AMENDMENT UNDER 37 C.F.R. § 1.111 U.S. Application No. 09/836,285

Inventor: Kouki OGAWA, et al.
Application No.: 09/836,285; Filed: April 18, 2001
Group Art Unit: 2827
For: PRINTED-WIRING SUBSTRATE AND
METHOD FOR FABRICATING THE SAME
SUGHRUE Tel. No. 202-293-7060; Ref. No. Q63647
ANNOTATED MARKED-UP DRAWING

Fig.5(a)

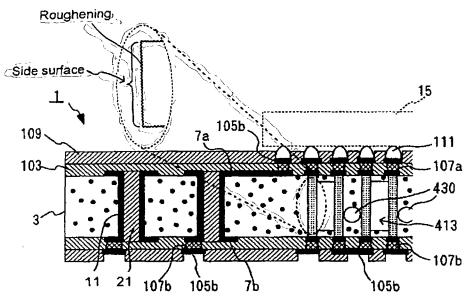
In response to the objection to the Drawings, Applicants submit herewith revised Fig. 5(a) showing capacitor element 413 having roughened side surfaces. The modification to Fig. 5(a) conforms the drawings to the description in the specification, as well as to other drawings as originally filed, and no new matter has been added.

The Examiner seems to take the position that because Fig. 5 (as originally filed) does not show roughened side surfaces, that in some way Applicants were not in possession of the invention of claim 8. This is unreasonable. It is tantamount to suggesting that Applicants do not have the right to claim an invention comprising the combination of, for example, claims 1, 2 and 8 as originally filed.

The Examiner is respectfully requested to approve the drawing changes to Fig. 5(a). Responsive to the claim objection, claim 7 has been amended as requested.
